# **An Opportunity Not To Be Missed**

Presentation to the Durham Planning Board  
on the Colonial Durham Associates Site Plan and CUP application  
May 19, 2021, by Robin Mower

Figure 7 – Heat Map of Nitrogen Loading by Subwatershed S1 and Potential Retrofit Opportunities for Lower Mill Pond Watershed | “Mill Pond Nutrient Control Measures Final Report,” Waterstone Engineering (2018)

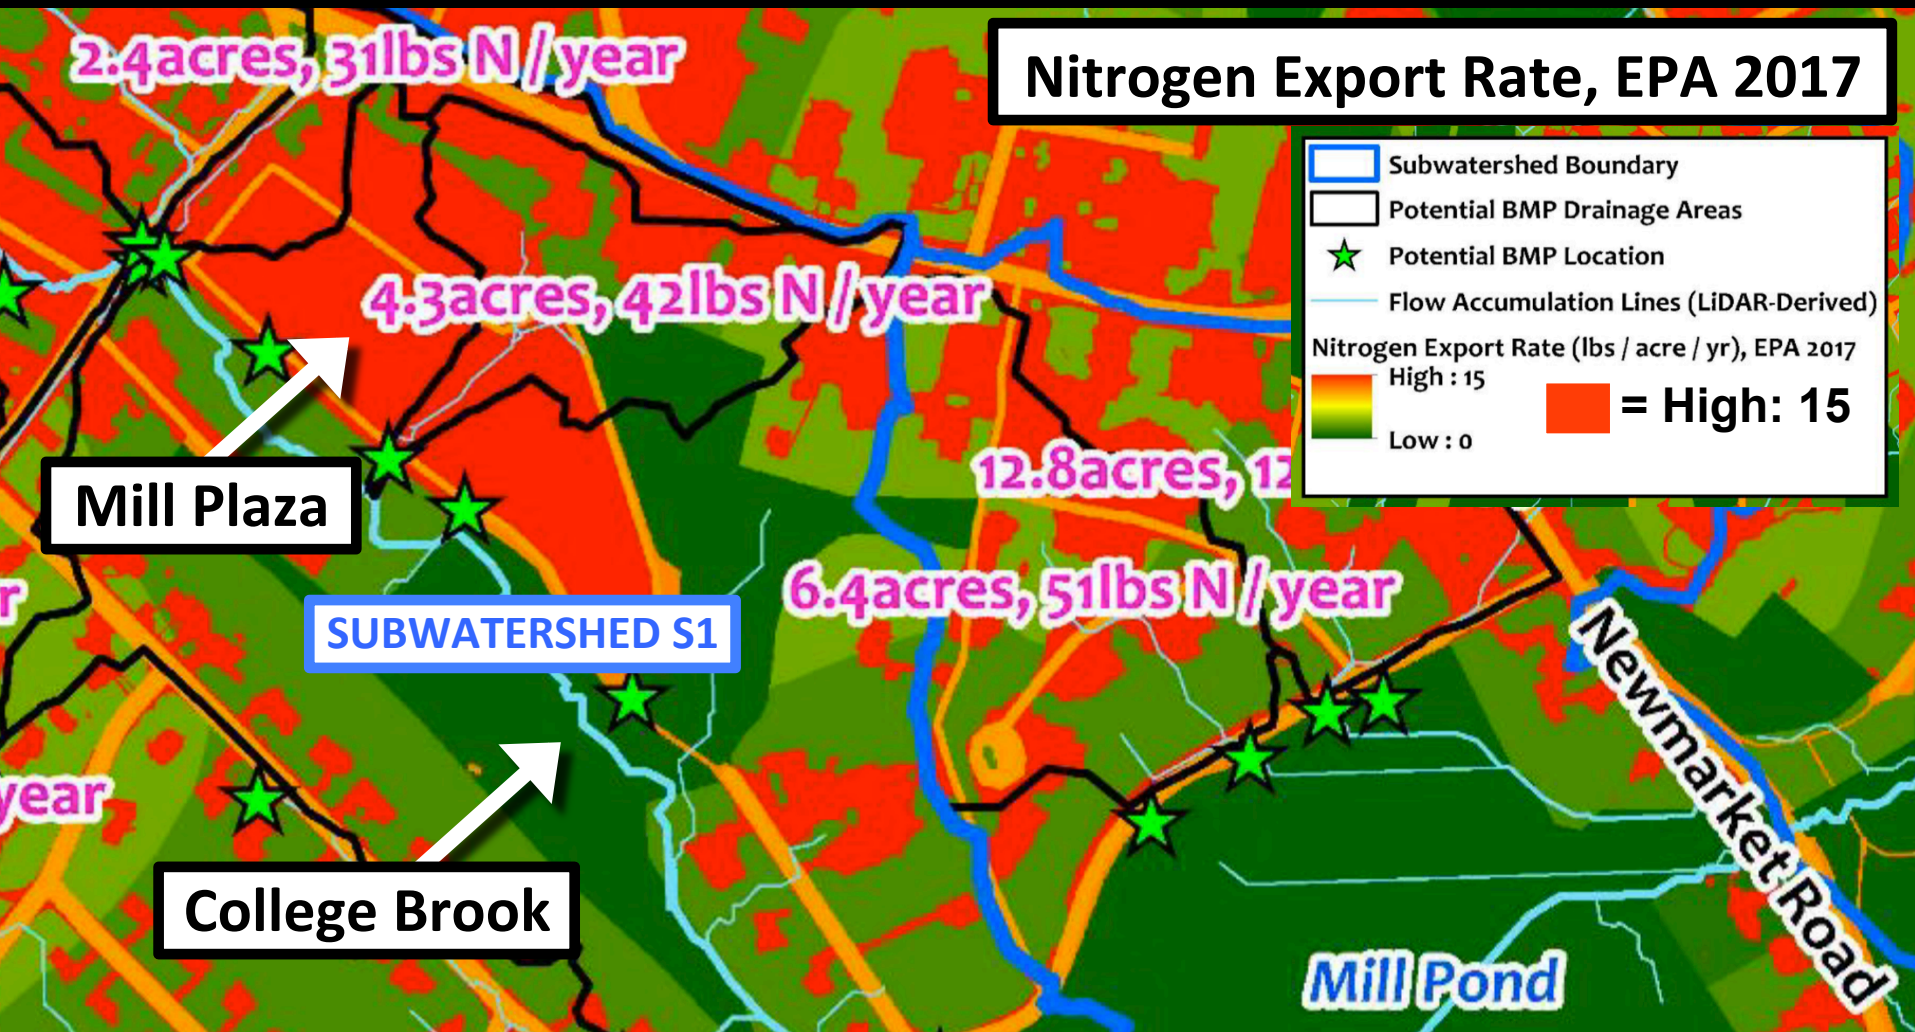
... then to Mill Pond, Oyster River, and Great Bay

Sheet C-102

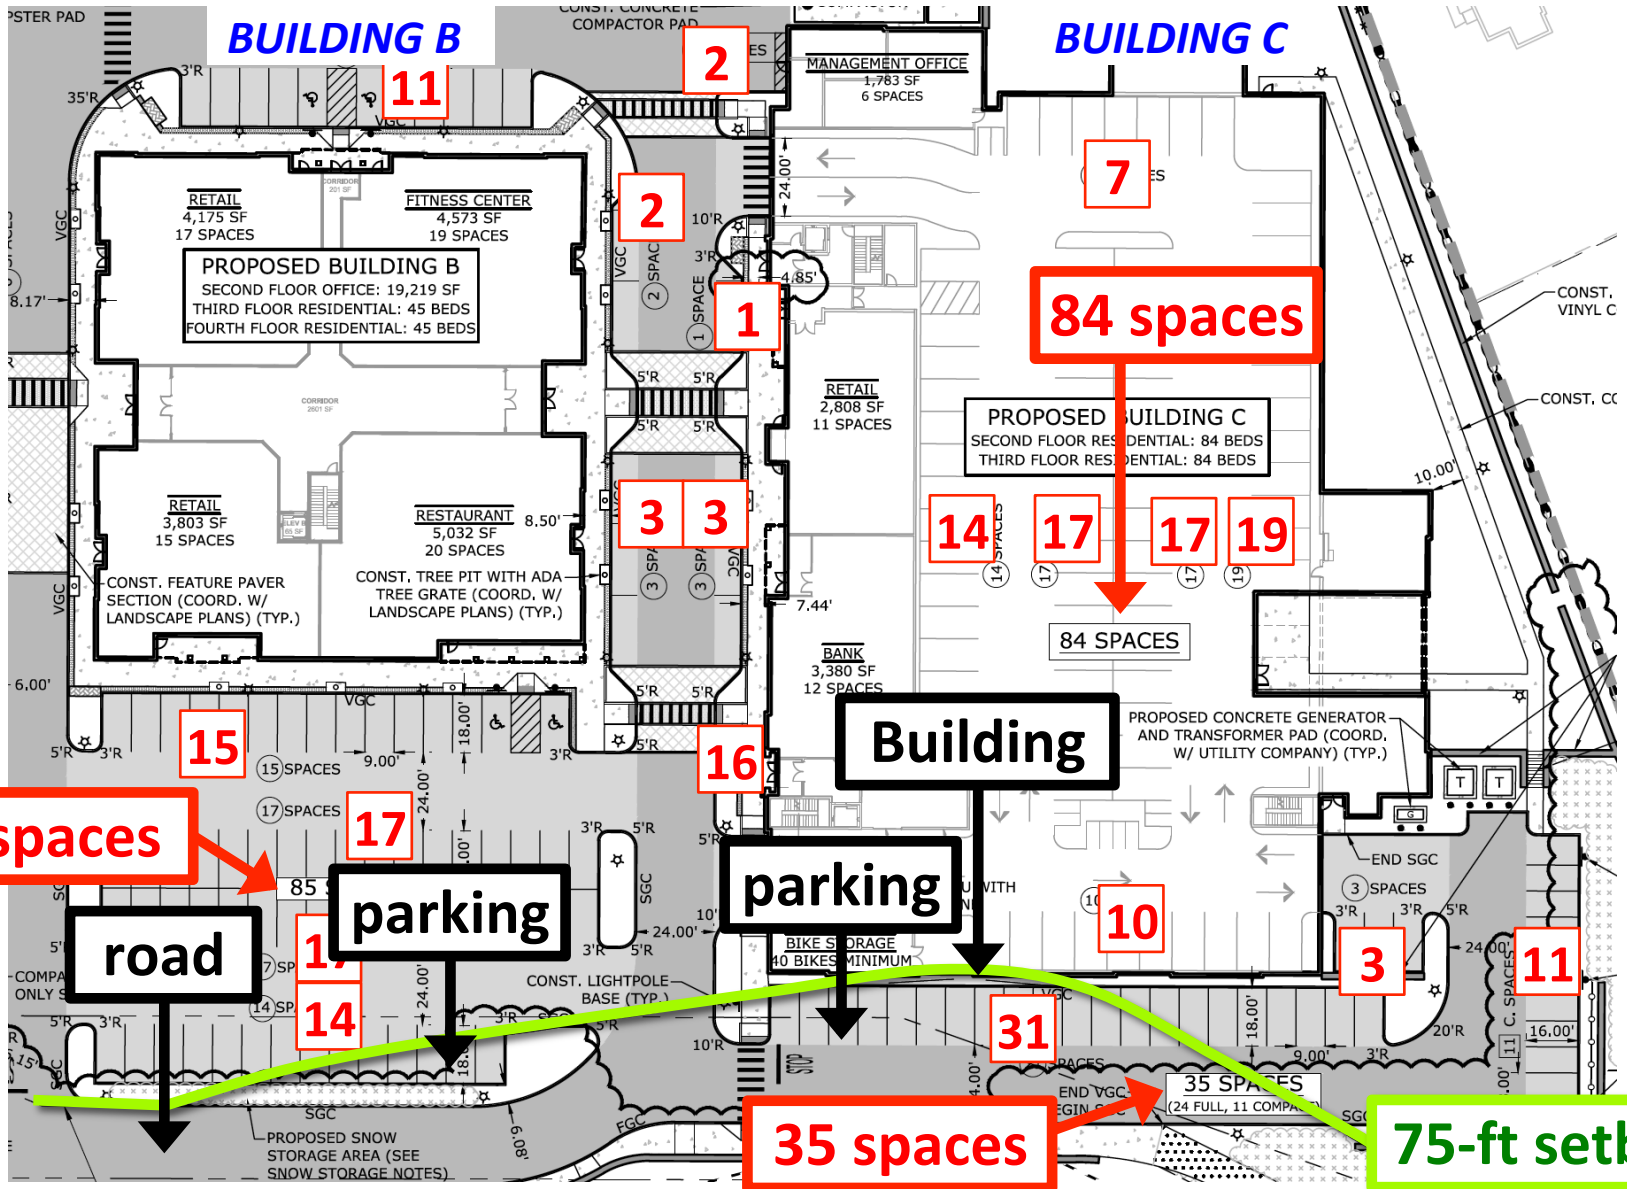
*March 10, 2021 site plan: What is planned for*

**THE SETBACK**

75-ft setback

Sheet C-104 Utilities Plan, March 10, 2021

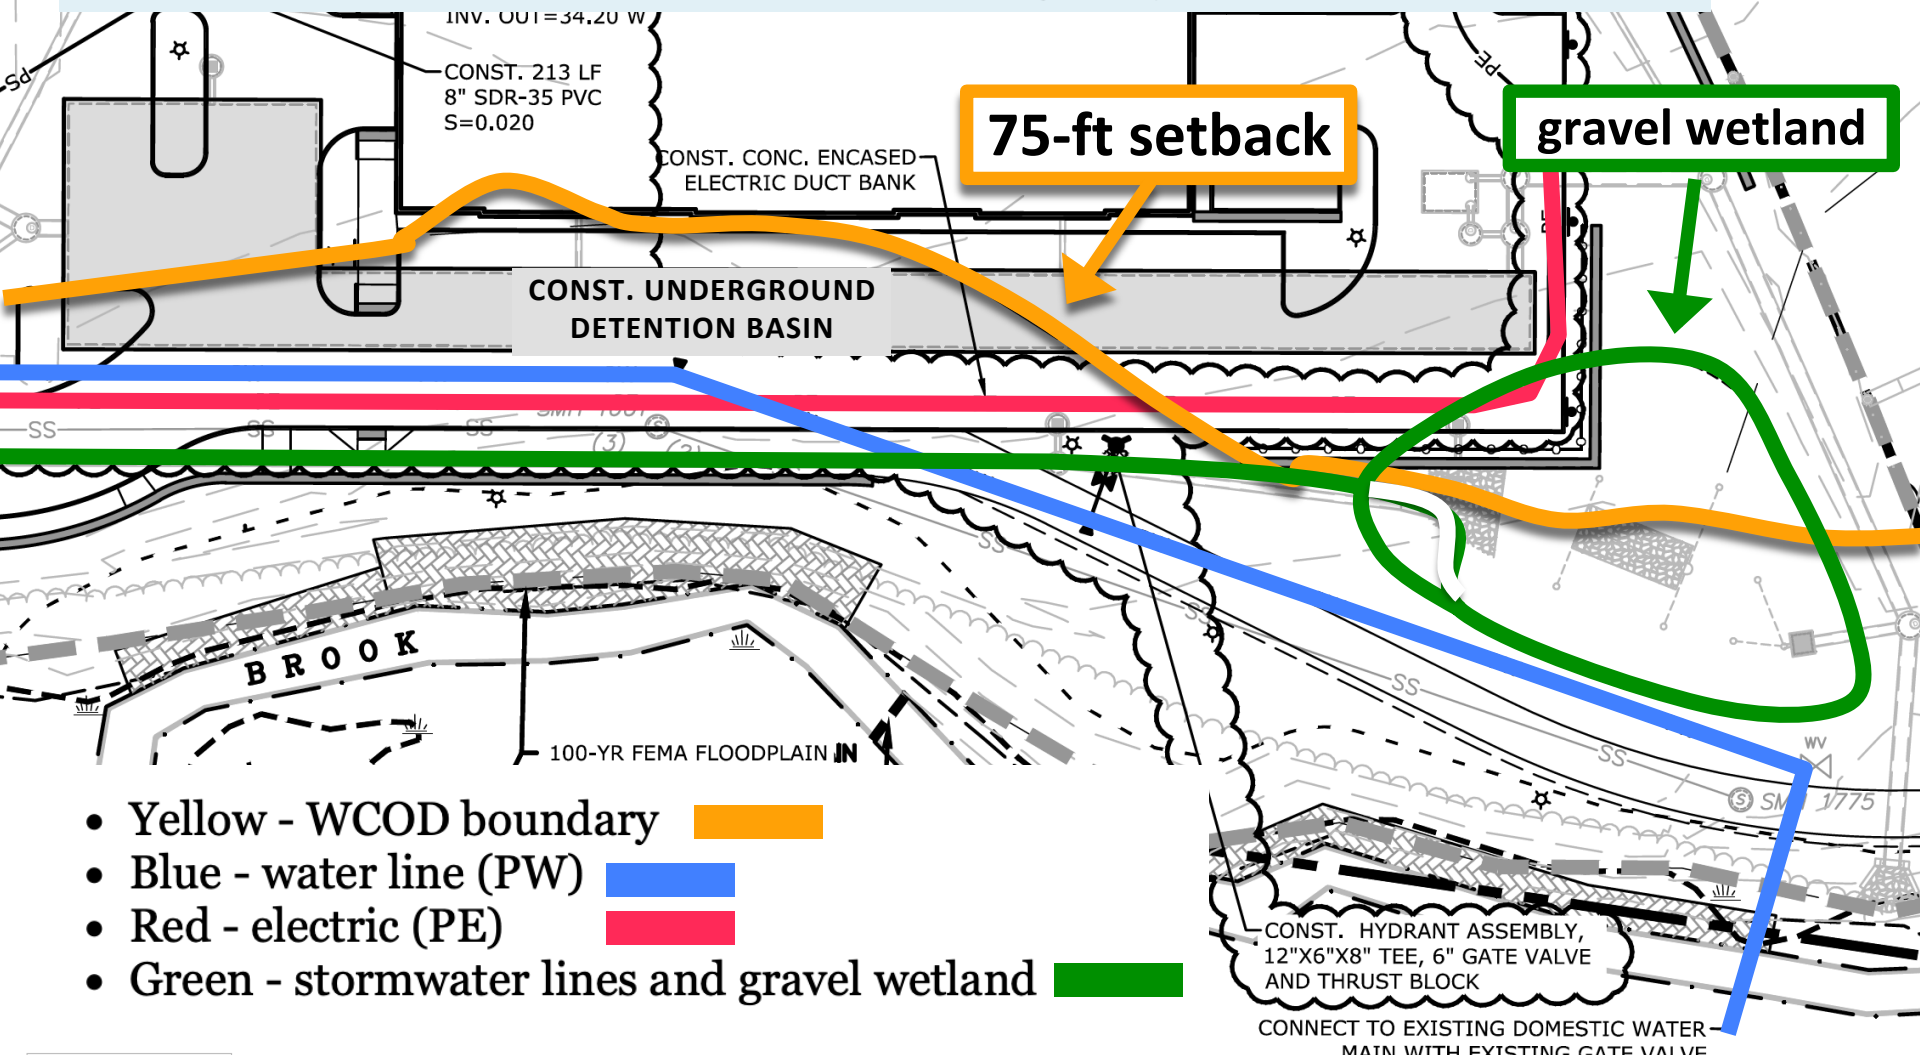
I don't know whether everyone is aware of all that's in the 75-ft setback, so I asked Rick Taintor if he would be willing to speak to this slide.
